Hurricane Planning Commission Meeting Agenda

August 24, 2023
5:00 PM

3. FSP23-28 WCUP23-02: Discussion and consideration of a possible approval of a final site plan and conditional use permit for a wall of greater height for the Dixie Power Pecan Valley Substation located at 2250 S 5140 W; Dixie Power, Applicant; Russ Condie, Agent.

Agenda Date:	08/24/2023
Application Number:	FSP23-28 WCUP23-02
Type of Application:	Final Site Plan
Action Type:	Administrative
Applicant:	Dixie Power (Russ Condie)
Agent:	Alliance Consulting LLC
Request:	Approve a final site plan for a power substation
Location:	2250 S 5140 W
Zoning:	Public Facility
General Plan Map:	Planned Community

Drawn By:	CJA	Scale:	1"=30'
Client No.	4621	Project No.	4621-22
Drawing Sheet	C1.1		
Sheet	2	of	24 Sheets

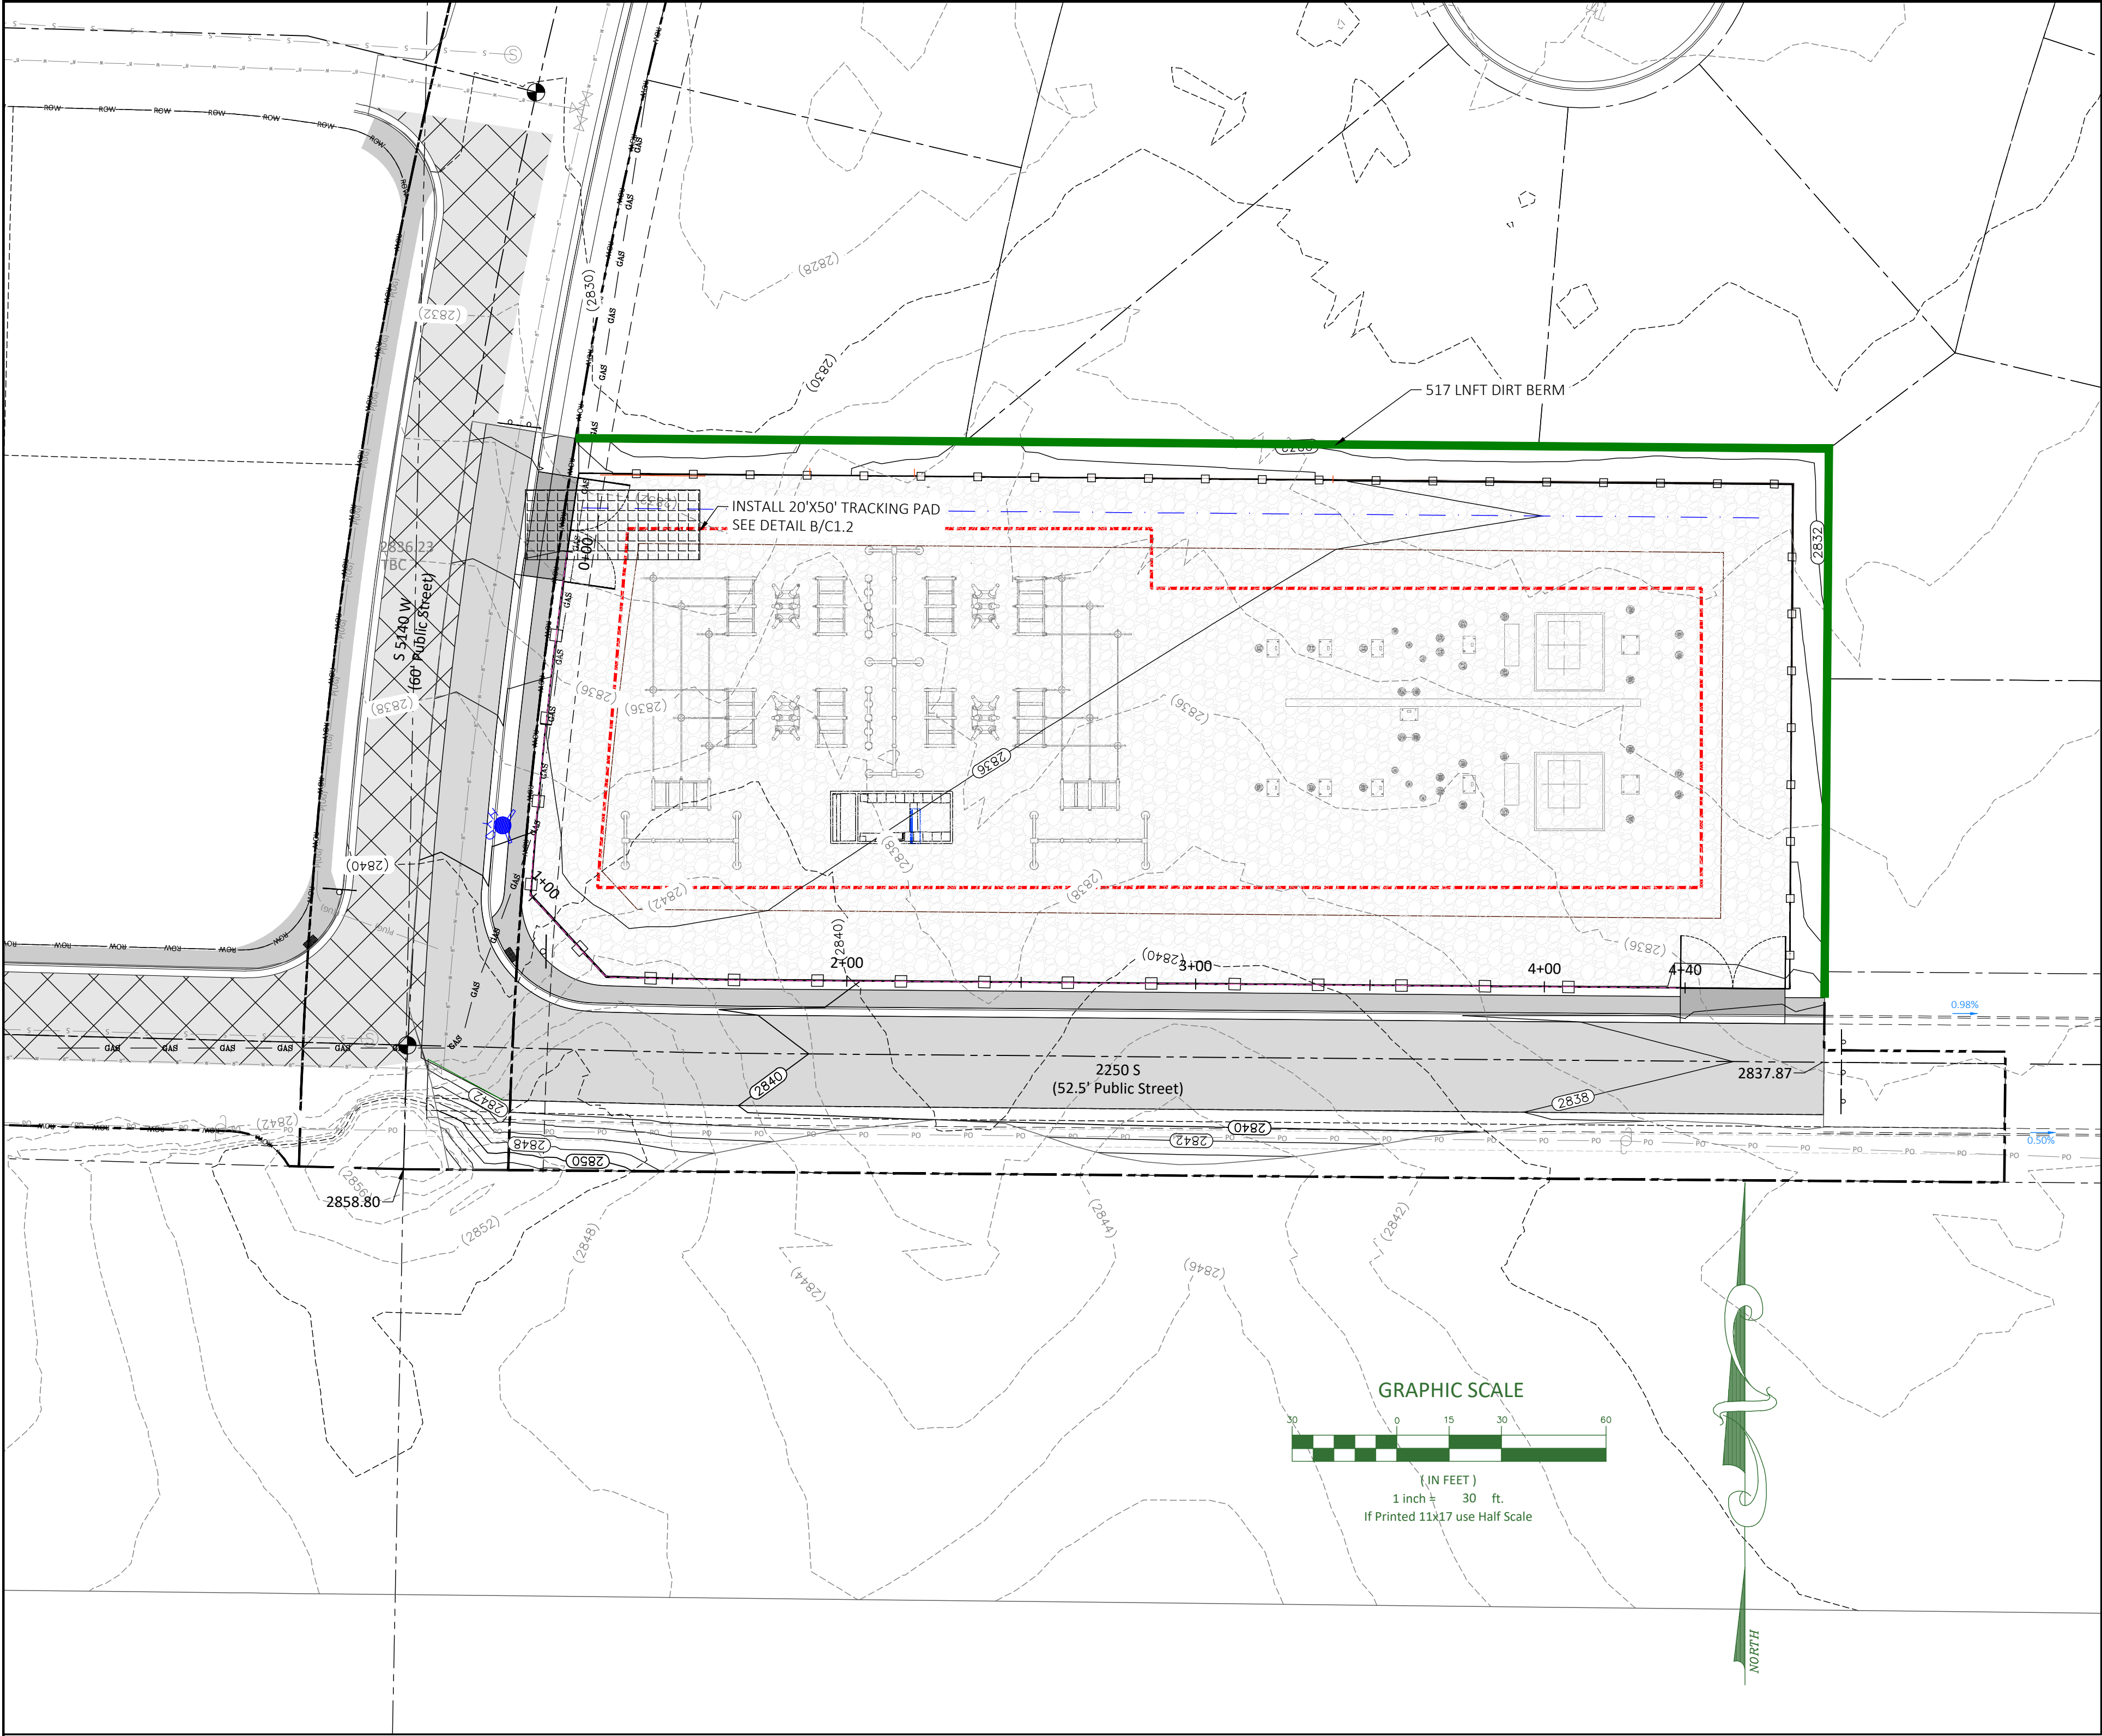
1. Hurricane City code states that a substation shall provide fencing. *Fencing: The perimeter of the public utility substation site shall be fenced if necessary to provide public safety or protect utility equipment. (10-45-4 (B)).* The applicant has requested a conditional use permit for an eight-foot wall. Under current code there are no standards by which the Planning Commission may or may not approve a greater height wall, although a proposed code change to add standards for greater height walls is anticipated to be adopted in the near future, and this proposed wall will meet the future code as well, including maintaining a 25 foot sight triangle on the corner of 5140 W and 2250 S.

- d. *The slope of any earth berm shall not exceed a vertical to horizontal ratio of one to two and shall be treated with suitable ground cover to prevent soil erosion.*
- The proposed plan does not show a sufficient landscape buffer and no trees or shrubs along the street frontages.
3. The plan meets setbacks for a substation to adjacent residents (30' min) and will be set back from all future roadways.
4. The applicant complies with all other aspects of the Hurricane City Code.

Recommendation: Staff finds that the final site plan complies with Hurricane City Standards, and Staff recommends this item be continued to allow for the applicant to present a landscape plan that meets city standards.
